APPENDIX 6: HISTORIC PRESERVATION REVIEW BOARD STAFF REPORTS

HISTORIC PRESERVATION REVIEW BOARD STAFF REPORT AND RECOMMENDATION

Landmark/District: **Decatur Street Car Barn/Northern Bus Garage** (X) Agenda
Address: **4701 14th Street, NW** () Consent Calendar
Meeting Date: **May 28, 2020** (X) New Construction
H.P.A. Numbers: **20-176** (X) Alteration
(X) Demolition

Figure 18. Proposed upper level plan of bus garage with historic overlay; the 14th street (west) façade will be retained along with the administrative offices and tower (Wendel)

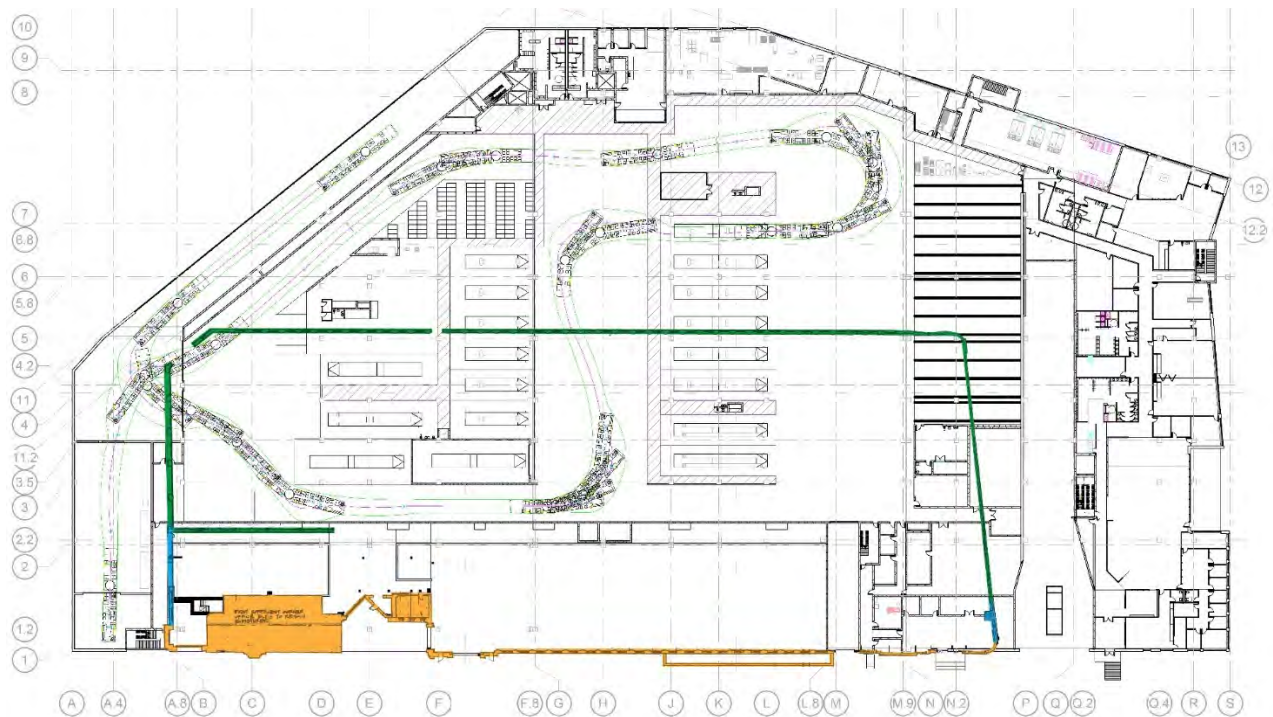
The drawing below shows the existing historic masonry walls overlaid on the design for the upper level of the new bus garage. (See **Figure 18**) Due to the alterations of the historic fabric and the need for a new bus garage that can accommodate efficient and safe vehicle circulation for 40'-0" and 60'-0" articulated buses, the existing bus garage must be replaced. The new bus garage will also ensure adequate height clearance for newer diesel buses and future overhead charging for electric buses, be reorganized to expand the number of maintenance bays and bus storage parking, incorporate a retail element for increased community integration, will be able to 100 percent filter exhaust air, and will reduce operating costs through sustainable strategies. The replacement bus garage project proposes that the east wall and the majority of the north and south walls be demolished. However, the entire west façade, including the administrative offices and tower, would be retained and preserved allowing for the conservation, repair, and cleaning of areas of damage, weathering, soiling, and staining. There is also the opportunity to replace the existing widows with replicas of the historic windows and restore window openings that were previously infilled or replaced with louvers. Such treatments would be developed as design coordination for the project continues. Portions of the upper level of the north and
